Thank you for your interest in the UW South Campus Force Main (SCFM) repair project. Please review the following April 16 job walk notes covering additional requirements, corrections and clarifications.

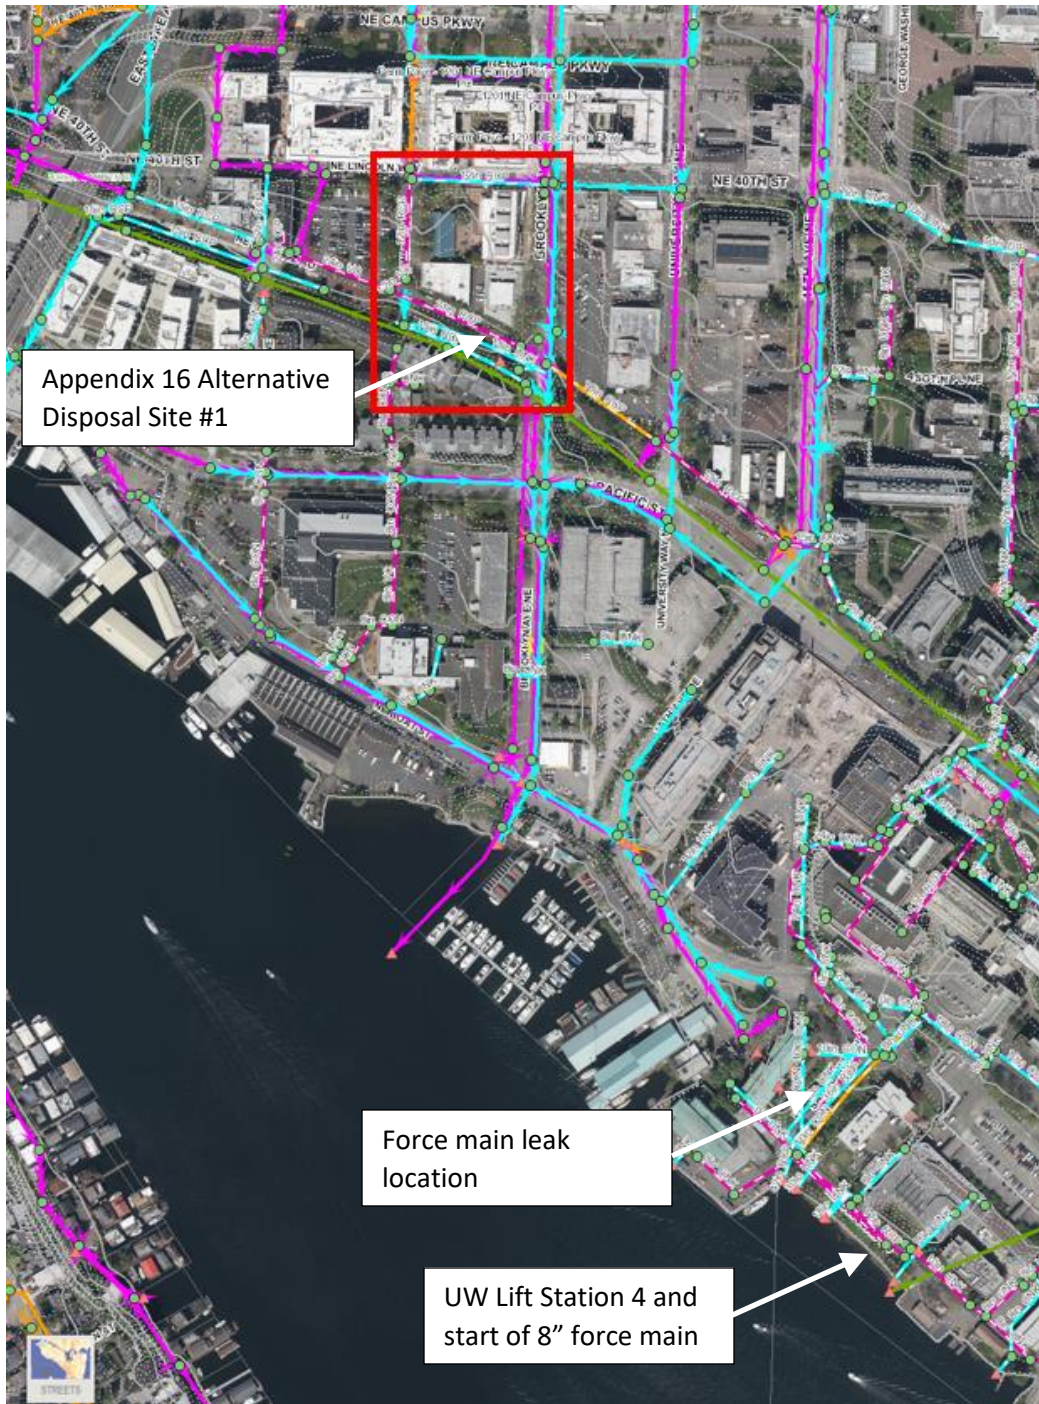
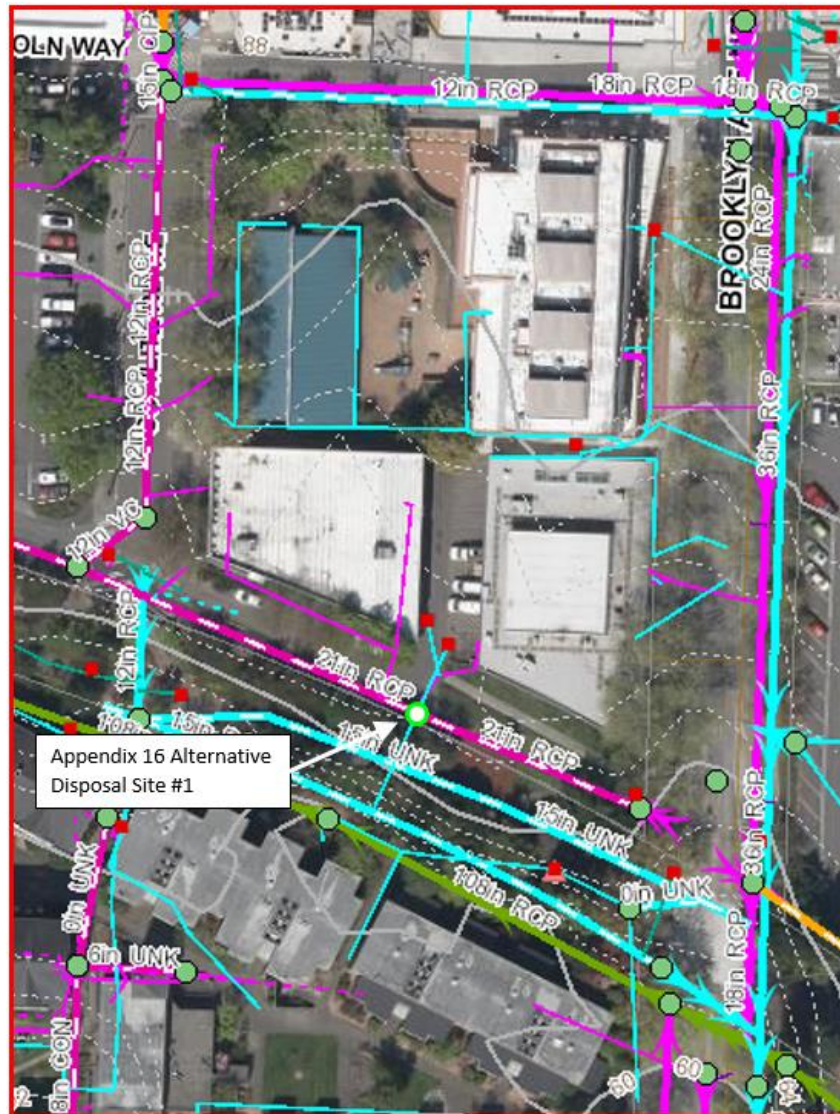
1. UPDATED ON-CAMPUS ALTERNATIVE DISPOSAL SITE. For the Solicitation, Attachment B: Appendix, delete items 10 and 11 and replace with item 16 discussed below as Alternative Disposal Site #1. The map snip below is from the City of Seattle, Development Services Office (DSO), Drainage and Sewer map at <https://www.seattle.gov/utilities/construction-resources/water-and-sewer-map>.

The enlarged area below from the previous map snip shows Alternative Disposal Site #1 at a manhole highlighted in green and denoted by a green arrow just south of the Southwest Maintenance Building at is 3902 Cowlitz Rd NE. Note that this structure is not included on the DSO map. This manhole and 21" side sewer owned by UW gravity drains into the King County sewer main denoted by the green line segment about a block west off photo. This alternative disposal site offers a safer, easier to control location on the UW owned dead-end NE Cowlitz Road. If this site is not available or insufficient, the contractor will need to transport effluent, pipe cleaning and other rinse water to a legal disposal facility such as the King County South Treatment Plant at 1200 Monster Road SW, Renton, WA 98057 at <https://www.kingcounty.gov/services/environment/wastewater/septage-disposal.aspx>.

UW will be responsible for the following:

- a. Coordinating the temporary relocation of vehicles from parking lot W11 as needed,
- b. Coordinating the temporary relocation and servicing of waste and recycle bins on the westbound lane of NE Cowlitz Road,
- c. Provide up to a dozen cattle gates for the contractor to use for site controls.

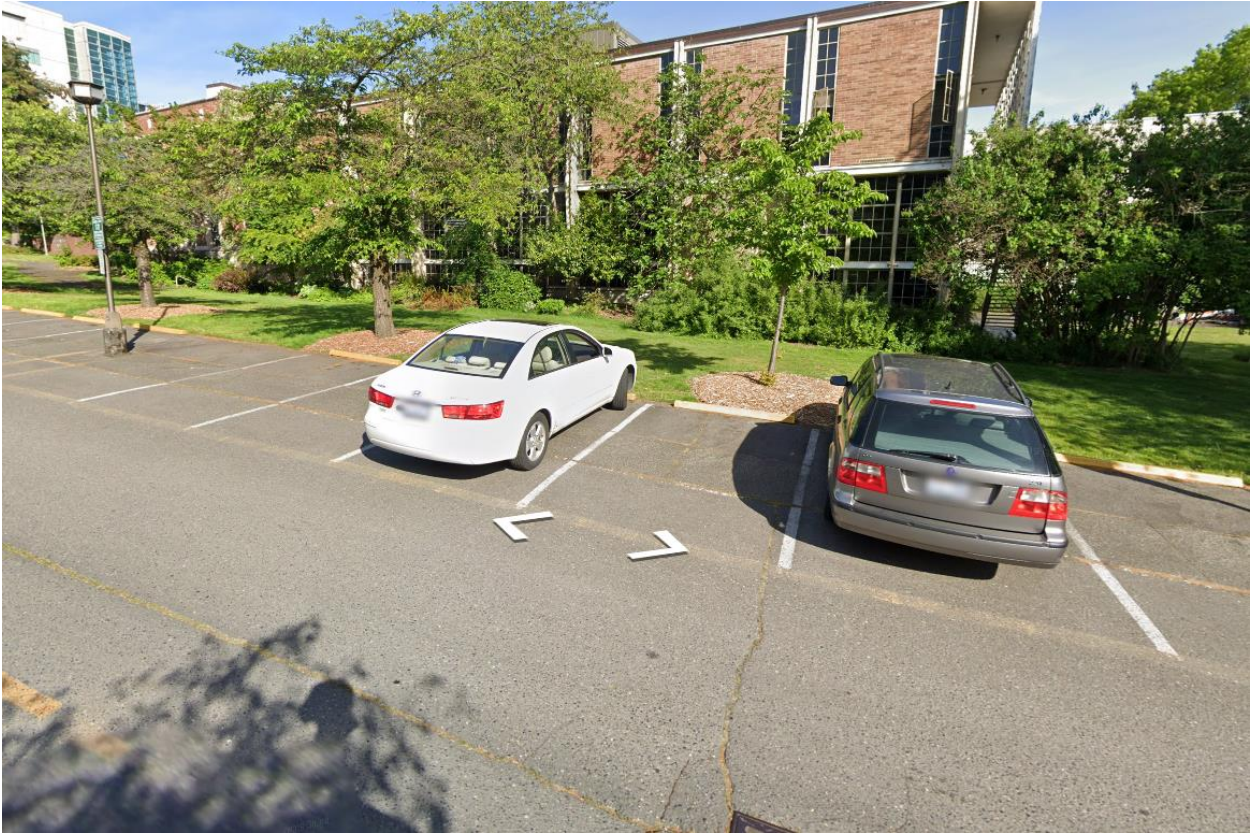
2. LANDSCAPE & TREE PROTECTION. The contractor shall avoid travel in and storage of materials and equipment in landscape areas and tree protection zones to avoid damage to soils, irrigation, tree canopy, tree stems, and tree roots. If contractor access into landscapes and tree protection areas is required, contractor shall coordinate with UW in advance to provide a means of protection approved by the owner. If tree roots  $\geq$  2 inches in diameter are encountered in the excavation site, contact Brian Davis for arborist support to cut the roots. Tree roots  $<$  2 inches in diameter shall be cleanly cut with sharp pruners to eliminate any damage prior to bedding and backfilling.

See visible tree roots and low canopy/branches at UW Lift Station 4 in the instantstreetview.com snip below, view to the northwest, at [https://www.instantstreetview.com/@47.649274,-122.311401,51.94h,-0.83p,0.24z,f2Eh9MzfrmTY1\\_Jl6eZAXQ](https://www.instantstreetview.com/@47.649274,-122.311401,51.94h,-0.83p,0.24z,f2Eh9MzfrmTY1_Jl6eZAXQ)

See trees near the leak location west of Harris Hydraulics Lab in the instantstreetview.com snip below, view to the east, at [https://www.instantstreetview.com/@47.65002,-122.311996,94.25h,-8.25p,0.24z,I5P3yxq6 IGg\\_dnoUavmtA](https://www.instantstreetview.com/@47.65002,-122.311996,94.25h,-8.25p,0.24z,I5P3yxq6 IGg_dnoUavmtA)

UW will be responsible for the following:

- a. Provide tree protection fencing prior to mobilization at Lift Station 4 and the leak location at Harris Hydraulics.
- b. Provide arborist support as needed.
- c. Shut off irrigation at Lift Station #4 and the leak location at Harris Hydraulics during repairs.
